CITY OF SACRAMENTO PLANNING COMMISSION  
1231 "I" STREET, SUITE 200, SACRAMENTO, CA 95814

- APPLICATION:**
- A. Negative Declaration.
  - B. Rezone 0.9± vacant acres from Standard Single Family (R-1) to the Single Family Alternative (R-1A) zone.
  - C. Tentative Map to subdivide 0.9± vacant acres into 11 lots (10 condominium lots and 1 common area lot) in the proposed Single Family Alternative (R-1A) zone.
  - D. Special Permit to develop 10 condominium units on 0.9± vacant acres in the proposed Single Family Alternative (R-1A) zone.
  - E. Special Permit to allow an infill 25 percent density bonus in order to construct 10 condominiums.

**LOCATION:** 351 Harding Avenue

**SITE PLAN**  
 INFILL DEVELOPMENT FOR  
 THE HARDING CONDOMINIUMS

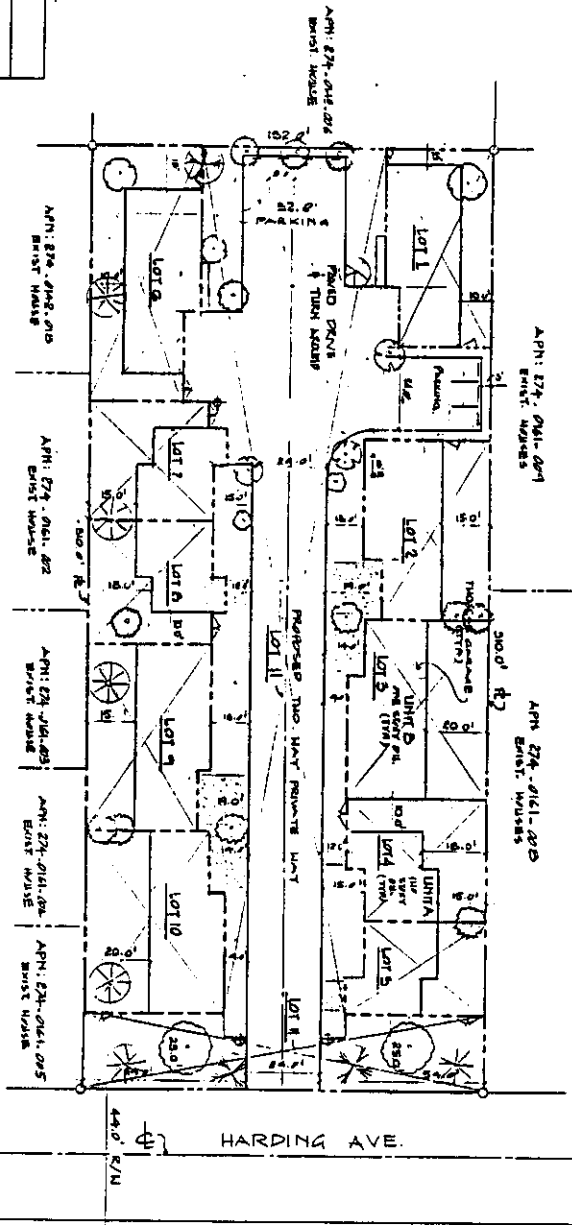
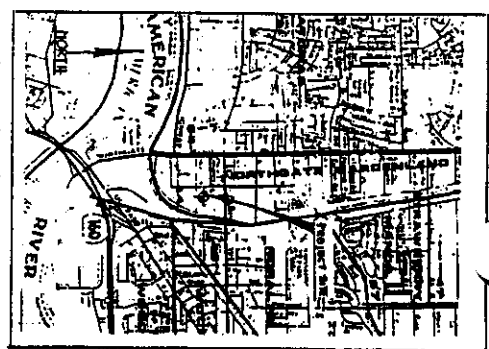
The site is designed such that there is a 24 foot driveway down the middle with five units on each side. The applicant has worked with the Fire Department in determining the necessary driveway width and turn-around area. The Fire Department has reviewed and approves of the current site design. Within this paved turn-around area, the applicant has provided seven guest parking spaces. All the paved driveway area should meet the 50 percent shade requirements of the Zoning Ordinance to reduce the impact of the paving. Staff also suggests the CC&Rs which are to be recorded, include a provision prohibiting parking within the driveways

to the garages. These driveways are too short to allow a vehicle to park without obstructing the common driveway. There should also be no parking along the common driveway.

The site plan indicates a 25 foot landscaped setback along Harding Avenue. The applicant should submit a detailed landscape plan for this 25 feet for review and approval of the Planning Director prior to the issuance of Building Permits. The site plan also indicates 15 feet of rear yard area for each unit except Lot 1 which has a 10 foot setback. This reduction was necessary to allow adequate area for the Fire Department turn-around. Lot 1 does, however, have a larger landscaped front yard than the other units.

Staff is concerned with the impact of the parking and driveway area on the adjacent properties. Staff suggests a six foot high decorative masonry wall be provided along the north property line of Lot 1, Lot 6 and the Common Area. The wall should also be provided along the eastern property line of Lot 1 and the Common Area. The design and location of the wall should be reviewed and approved by the Planning Director prior to the issuance of Building Permits. The perimeter around the remainder of the site should be a wood fence.

1. All the paved driveway area shall meet the 50 percent shade requirements of the Zoning Ordinance.
2. The CC&Rs shall be reviewed and approved by the Planning Director. The CC&Rs which are recorded, shall include a provision prohibiting parking within the driveways to the garages. There also be no parking allowed along the common driveway.

3. The applicant shall submit a detailed landscape plan for the 25 foot landscaped setback along Harding Avenue for review and approval of the Planning Director prior to the issuance of Building Permits.

4. The applicant shall construct a decorative masonry wall along the north property line of Lot 1, Lot 6 and the Common Area. The wall shall also be provided along the eastern property line of Lot 1 and the Common Area. The design and location of the wall shall be reviewed and approved by the Planning Director prior to the issuance of Building Permits. The perimeter around the remainder of the site should be a wood fence.

TYPICAL TYPE UNIT B, ELEVATIONS

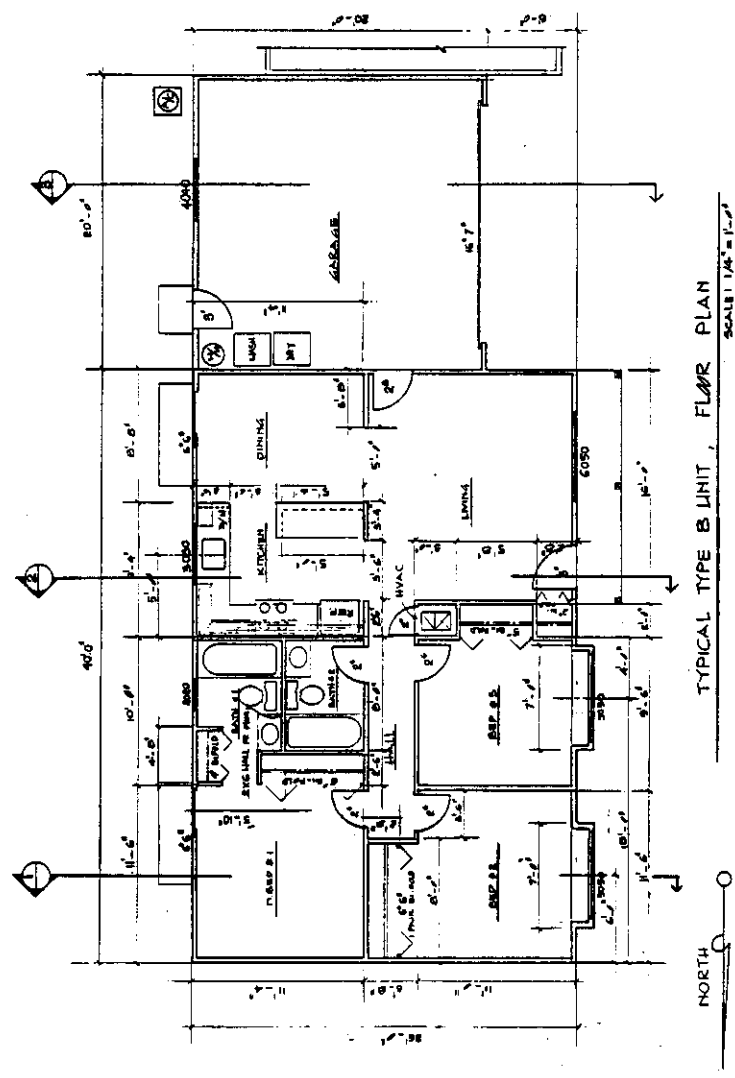
The proposed building materials consist of wood siding and asphalt shingles. Staff suggests revised elevations be submitted for review and approval of the Planning Director prior to the issuance of Building Permits. The applicant should attempt to reorient the building on Lot 5 to have the front door facing Harding Avenue to allow for a more single family appearance. In addition, all windows facing Harding Avenue and the private drive should be gridded as shown on the elevations. The siding should be horizontal 6 inch lap siding on all sides for the two story units. The single story units may use other material on the sides or front, except for Lot 10, which should have the lap siding on the elevation facing Harding Avenue. Fascia boards and gutters should be provided where necessary and all vent should be trimmed in wood. There should be no air conditioning units on the roof. Staff also suggests the roof material be a minimum of 25 year laminated dimensional composition shingles. In addition, the front doors should be wood or metal panel decorative doors as shown on the plans. The garage doors should be metal sections with raised panels as shown on the elevations. The single car garage door should be a minimum of 9 feet wide. Staff suggests the colors be in a pastel range with an accent trim that is not too dark.

5. The construction of the condominiums shall meet all requirements of the Building Code.
6. The applicant shall submit revised elevations for review and approval of the Planning Director prior to the issuance of Building Permits. The revised elevations shall include at a minimum:

- a. The building located on Lot 10 shall be reoriented to include the front entrance facing Harding Avenue.
  - b. All windows facing Harding Avenue and the private drive shall be gridded as shown on the elevations.

- c. The siding material shall be horizontal 6 inch lap siding on all sides for the two story units. The single story units may use other material on the sides or front, except for Lot 10, which shall have the lap siding on the elevation facing Harding Avenue.
- d. Fascia boards and gutters shall be provided where necessary and all vent shall be trimmed in wood.
- e. There shall be no air conditioning units on the roof.
- f. The roof material shall be a minimum of 25 year laminated dimensional composition shingles.
- g. The front doors shall be wood or metal panel decorative doors and the garage doors shall be metal sectionals with raised panels as shown on the elevations. The single car garage door shall be a minimum of 9 feet wide.
